November 14, 2019

**Addendum #2 To
Request for Proposal
For Cohn Building Student Commons Construction: Project 048-291367 and
For Cohn Building Student Commons FFE: Project 048-291367
Dated November 1, 2019**

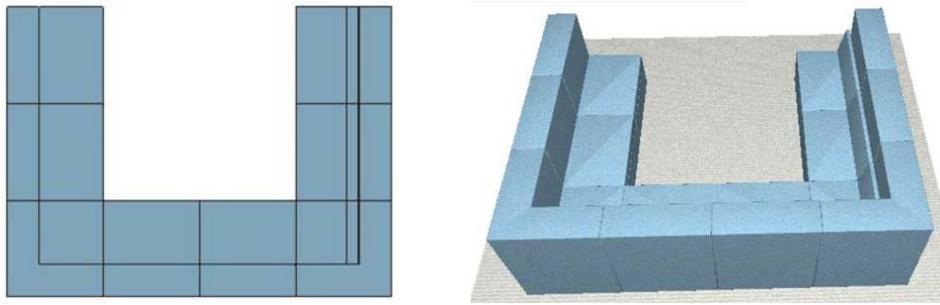
Question 21 – Clarification sought, please see a screenshot from CET, showing what is included in the quote. Based on the line drawing that was provided in the bid package, only included cushions on one side as depicted.
